## CHAPTER B.

### EVALUATION REPORTS AND CROSS SECTIONS

**1. Virginia By Products Division of Knox Creek  
Permit 1100321**

SECTION B-B

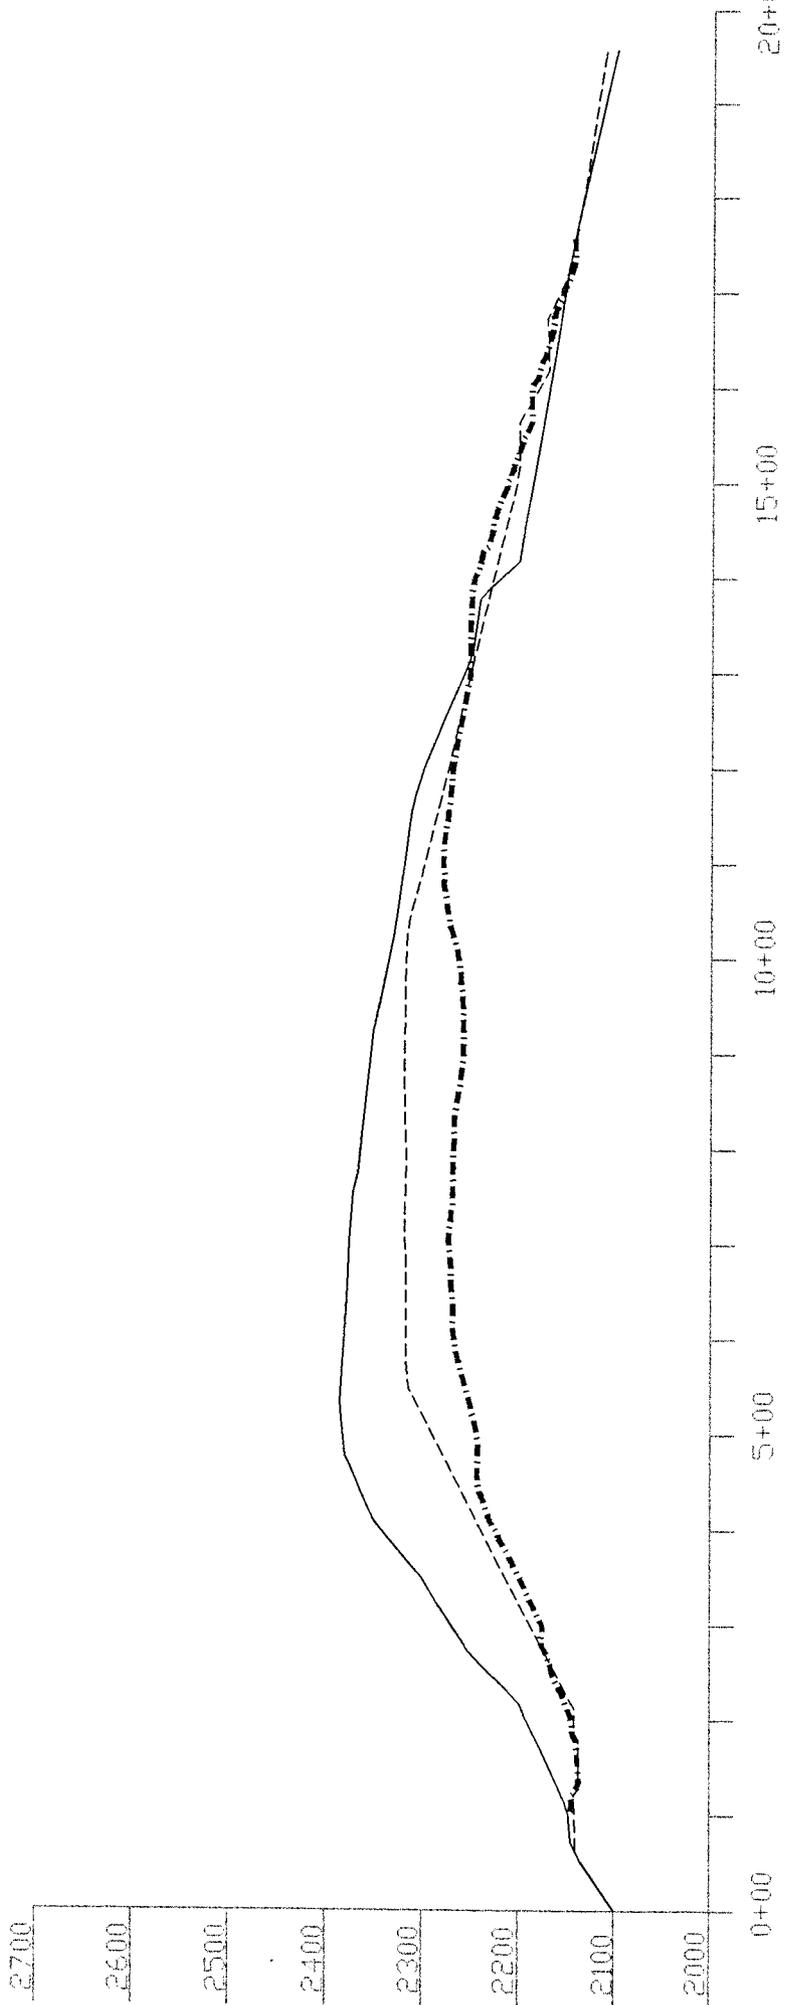
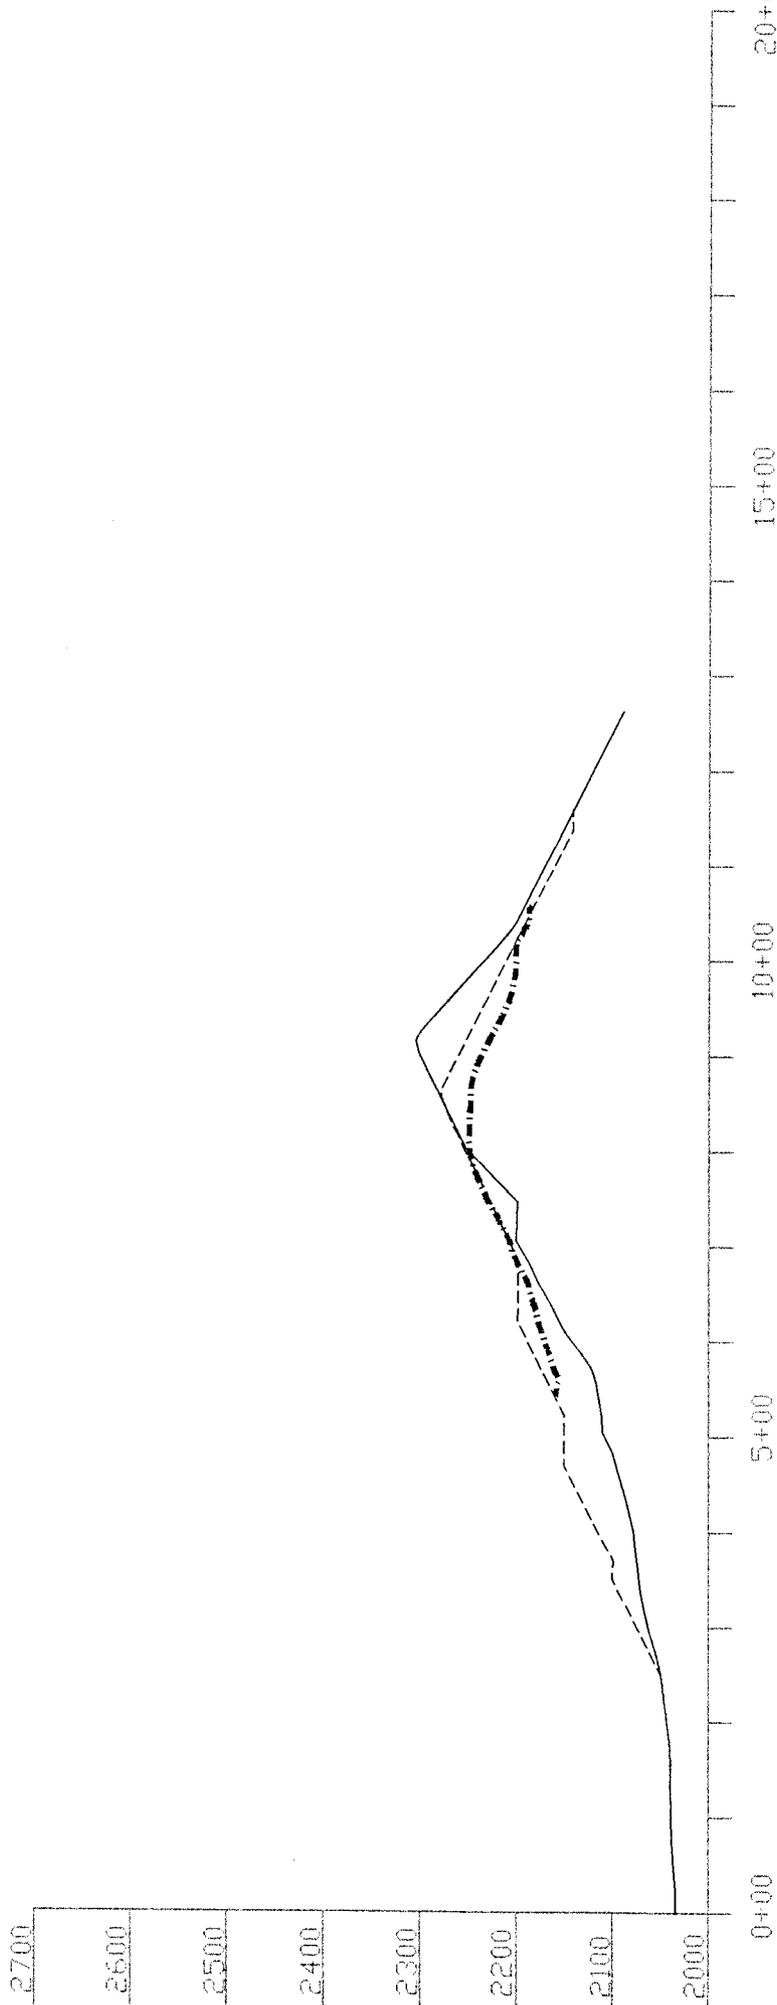
**Approximate Original Contour:** As approved by Virginia DMME/DMLR, the permit area is being returned to AOC. A GPS survey found that the contour had been reduced a maximum of -140 feet with an average change of -45 feet. Field observations did not identify any major changes from the original drainage.

SECTION AA

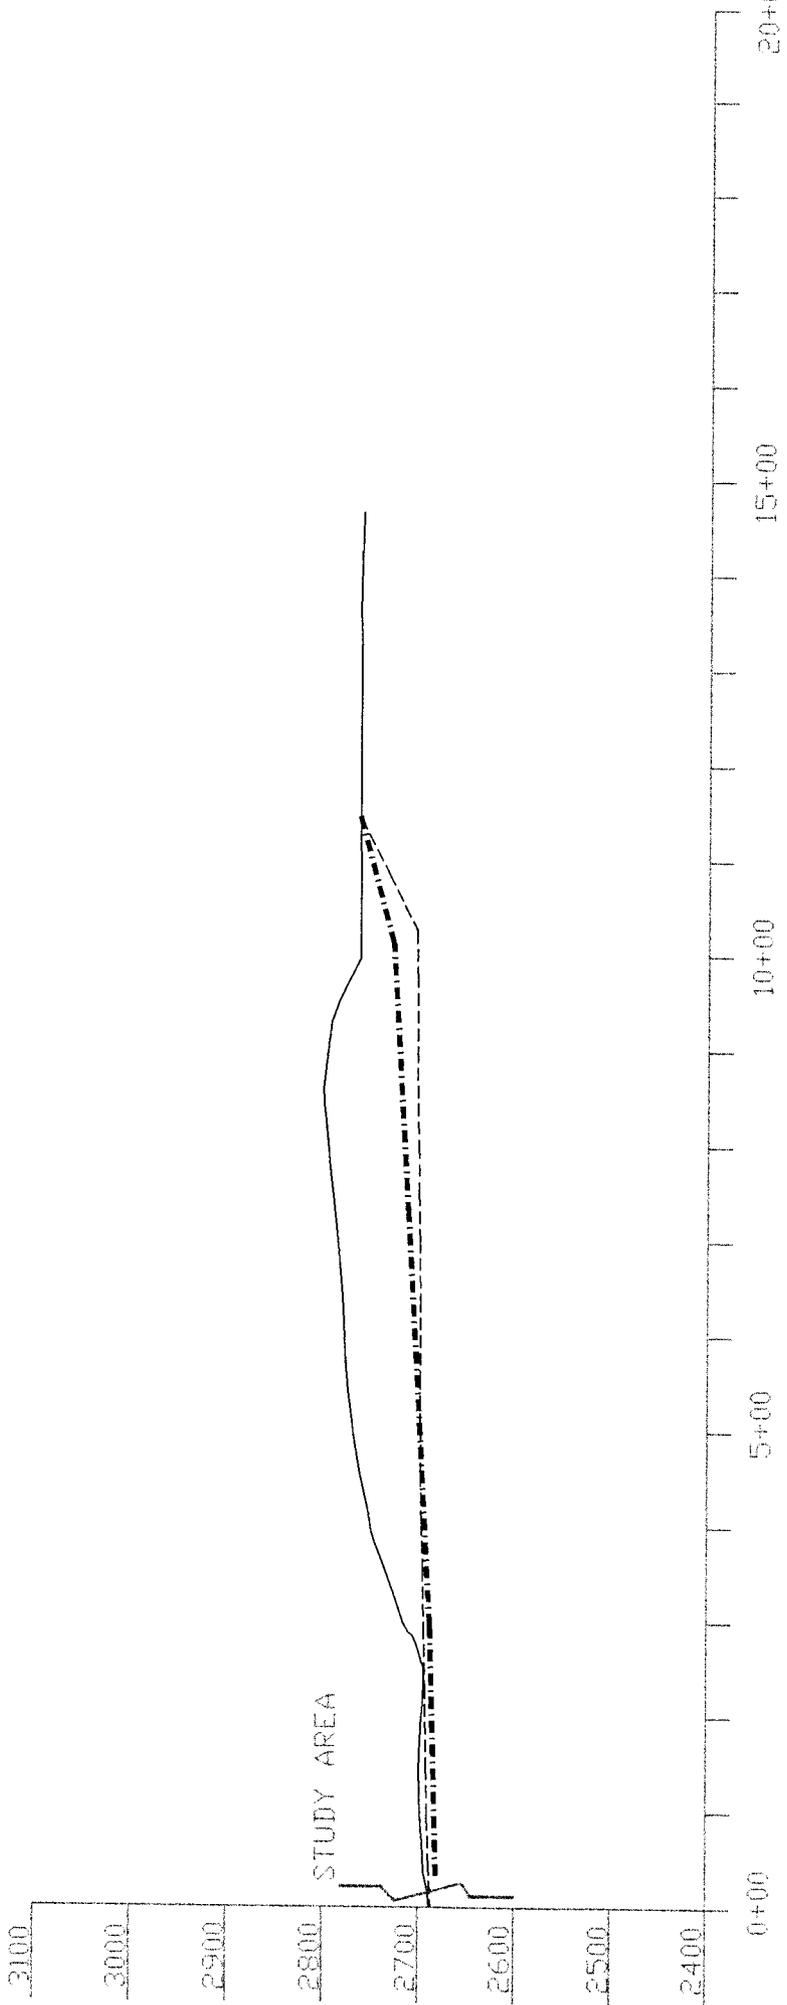
**Approximate Original Contour:** The proposed backfill on the mountaintop removal areas was to be a flat to gently rolling plateau. The global positioning system (GPS) field cross-sections A and C conformed closely to the approved cross-sections A and C; however, GPS field cross-section D was higher in elevation than the originally approved cross-section D. The GPS survey identified an maximum change in elevation of -100 feet, with an average change of -52 feet. Runoff patterns were not significantly altered by this mining operation.

SECTION A-A

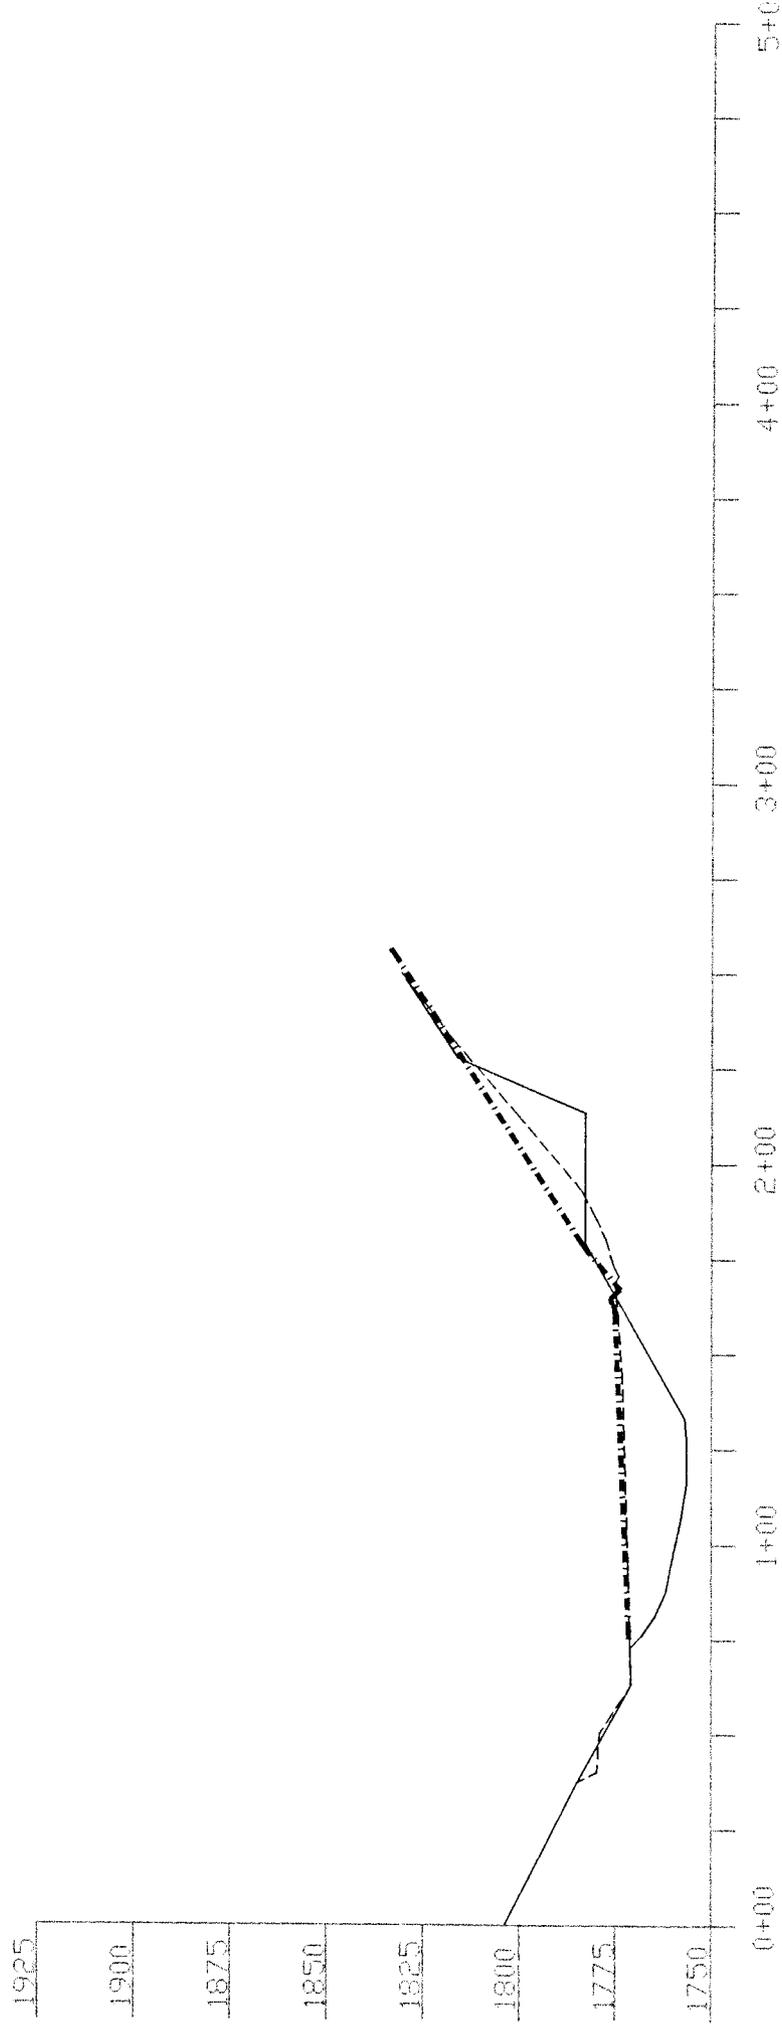
**Approximate Original Contour:** The AOC variance approved at portal area B changed the backfill regrade from highwall elimination using a premining 32 degree backfill slope to highwall elimination using a 38 degree backfill slope, as shown by cross-section A. Our GPS survey of this area showed maximum elevation change of +20 feet and an average change of +8 feet. Runoff patterns were not significantly altered by this mining operation.

SECTION A

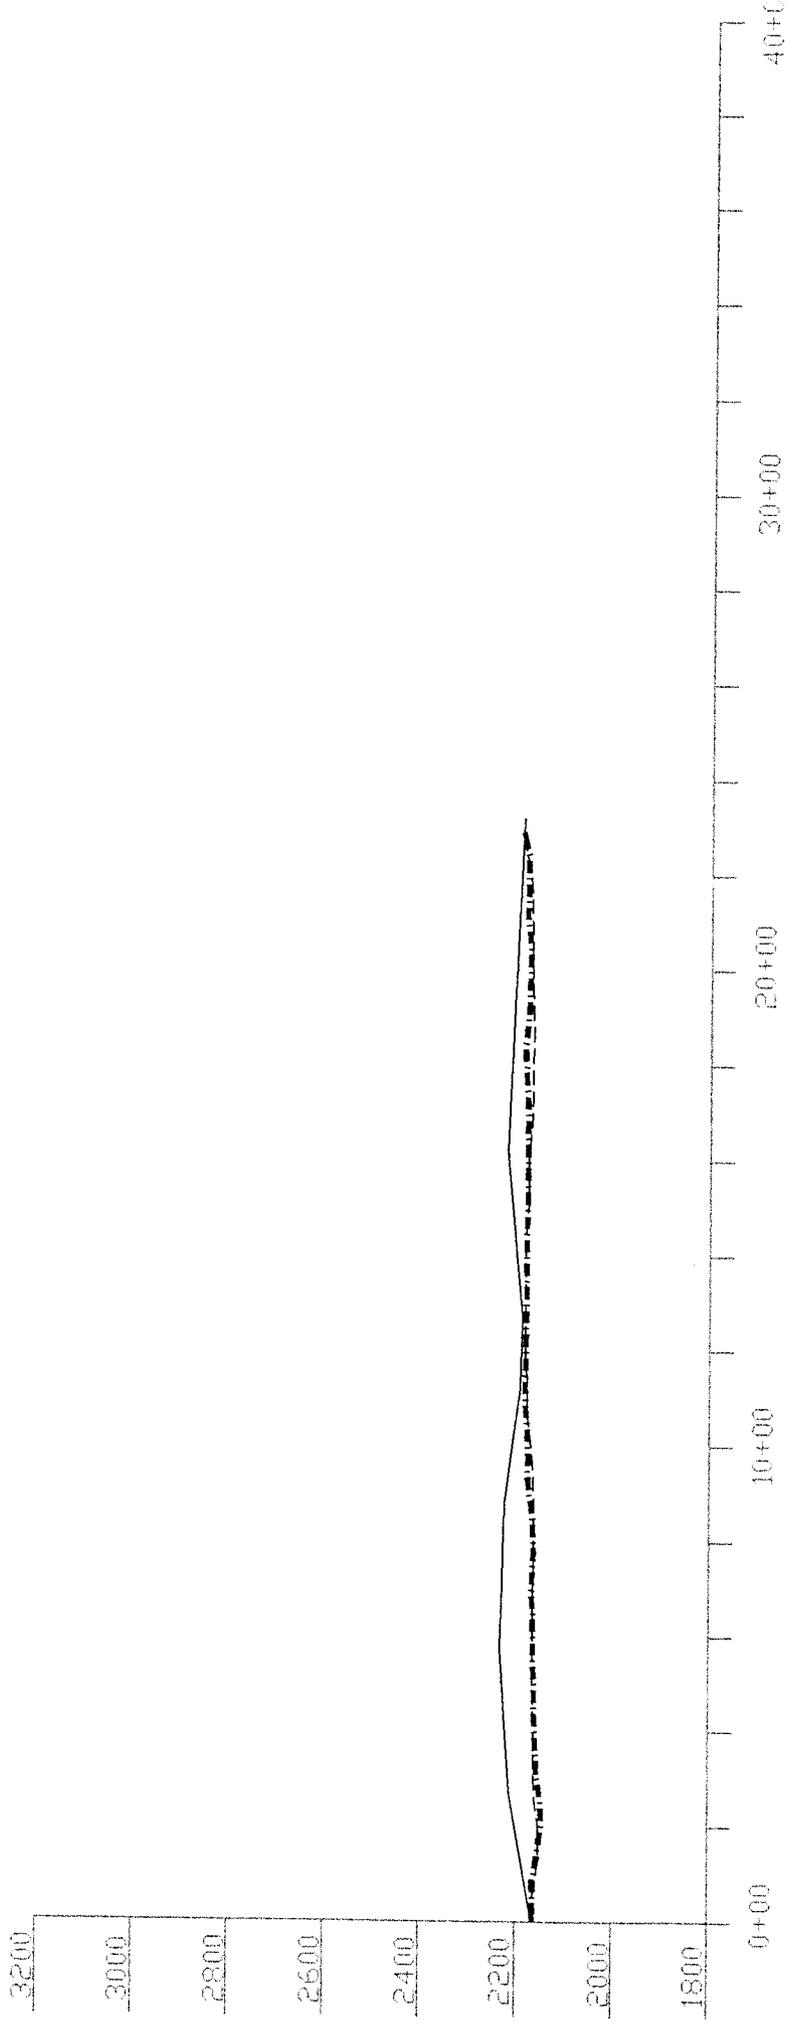
**Approximate Original Contour:** The proposed backfill was similar to the premining configuration except it was 20 feet higher (original cross-section A) and the pre-existing highwalls were eliminated. Our GPS survey found that the operations decreased the elevation by a maximum of 60 feet, with an average change of -32 feet. Runoff patterns were not significantly altered by mining activities.
